REMARKS

This response addresses the issues raised by the Examiner in the Office Action mailed April 23, 2004. Initially, Applicants would like to thank the Examiner for the careful consideration given in this case. The Claims were 1-9. Claims 1-9 have been canceled and Claims 10-18 have been added. Thus, Claims 10-18 are pending in this case all to more clearly and distinctly claim Applicants' invention. Applicants respectfully request entry of the amendments as they place the application in condition for allowance or in better condition for possible appeal.

Fig. 1

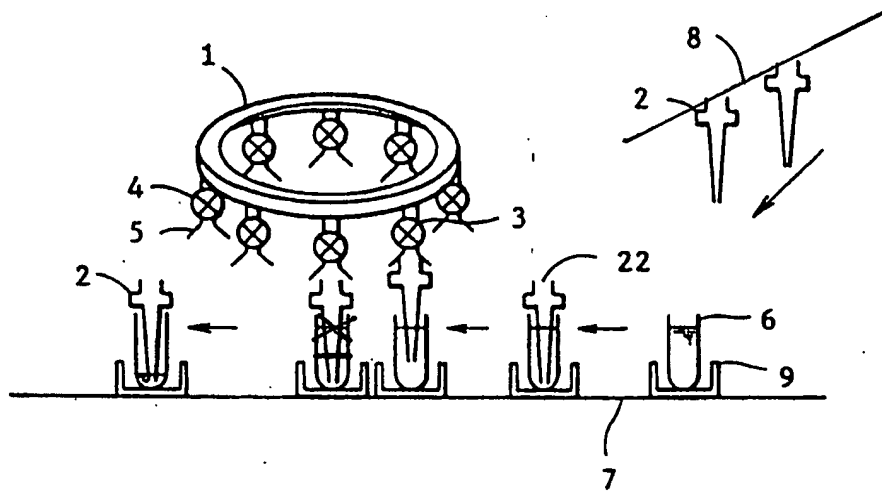
The attached sheet of drawings includes changes to Figure 1 and Figure 2. This sheet replaces the original sheet including Figure 1 and Figure 2. In Figure 1, the “suction line” is depicted by a diagonal line on the right side of the drawing. In addition, the blood level of the second blood collecting tube from the left is lowered in Figure 1. Further, the lead line of reference character “8” is corrected. In Figure 2, reference character “1” is changed to “1”

Fig. 6

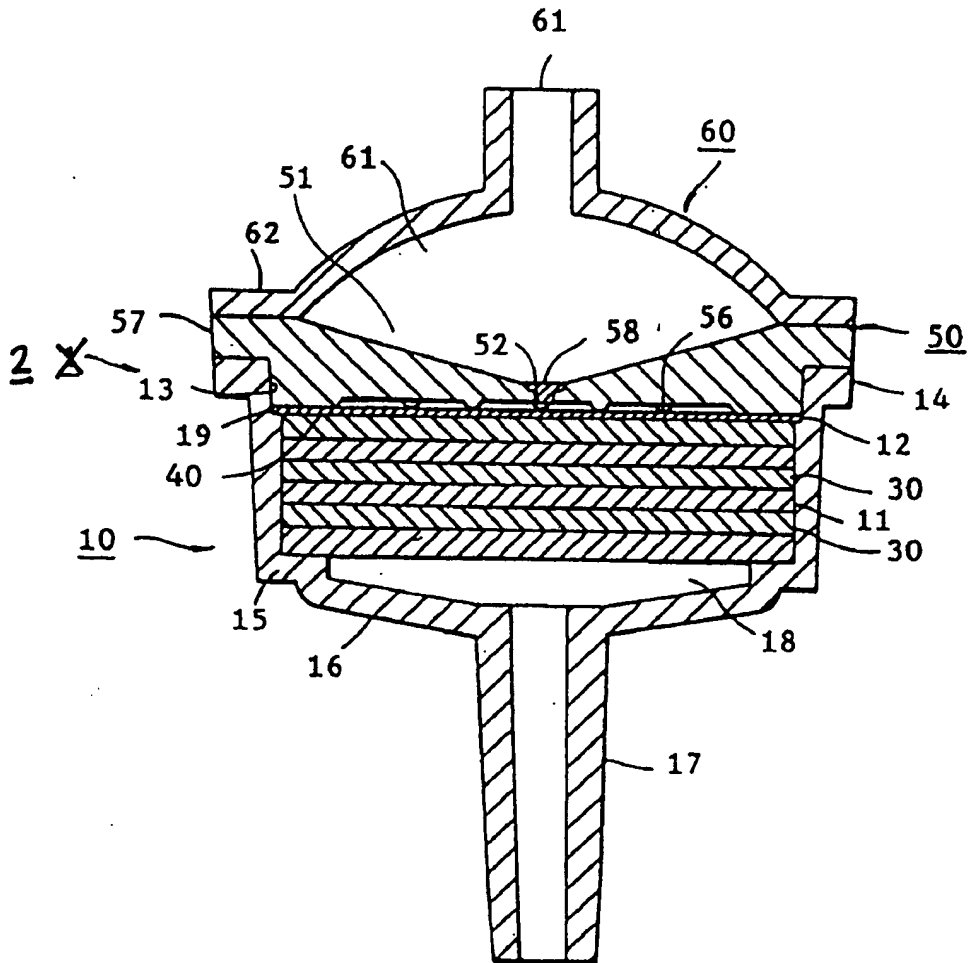
The attached sheet of drawing also includes changes to Figure 6. This sheet replaces the original sheet including Figure 6. In Figure 6, reference character “1” is changed to “2”.
